ECR #: P10

Title: Rail Bumper Dimension Incorrect in Figure 3.7

Spec Version: NLX 1.2

Figure 3.7: NLX Motherboard Dimensions—13.6 inches Secondary Side

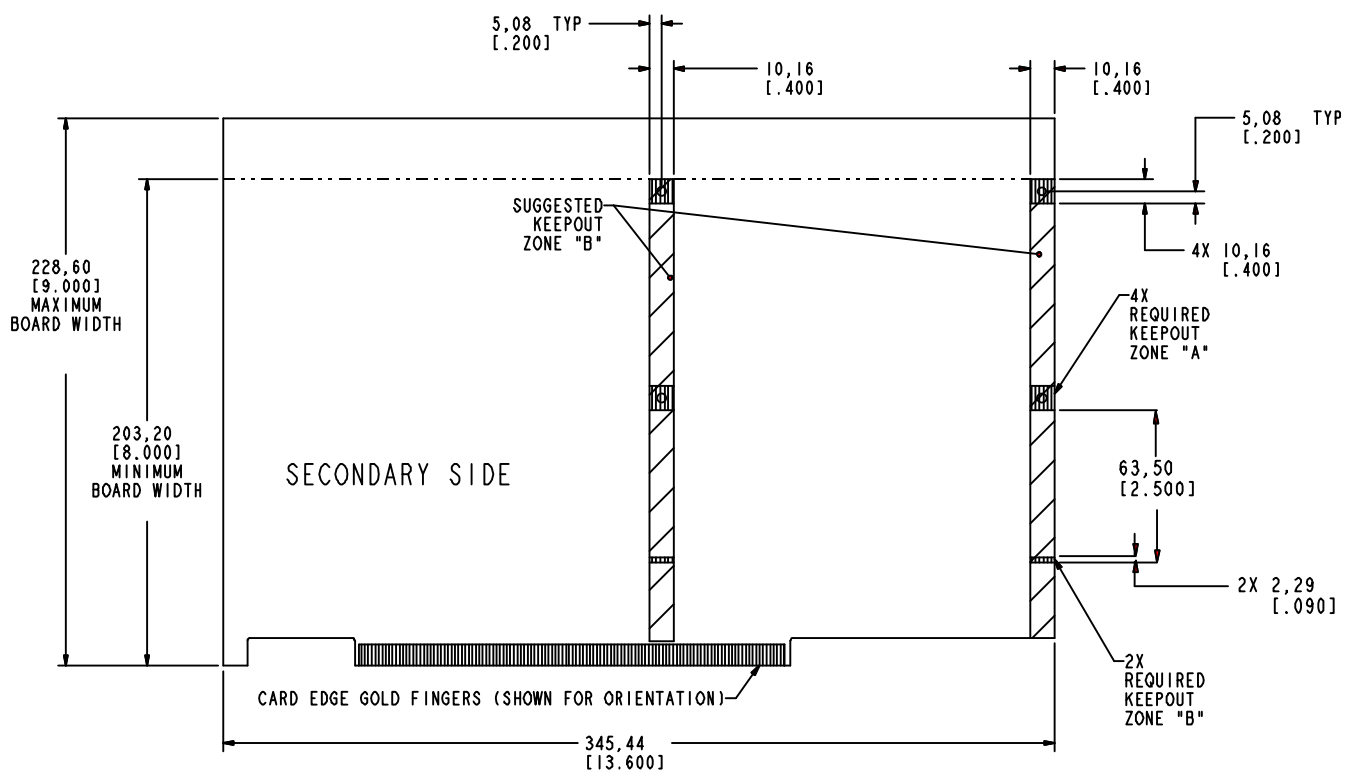
The measurement given as 2.5" (63.5mm) from zone A to zone B incorrectly points to the top of the keepout zone B. The correct measurement is from the bottom of zone B.

Because of a drawing error in Figure 3.7, the measurement marking for the rail bumper keepout erroneously appears to point to the top of zone B. The corrected figure below is consistent with Figures 3.3 and 3.5, which specify the distance to the bottom of zone B.

Replace Figure 3.7 with the following figure:
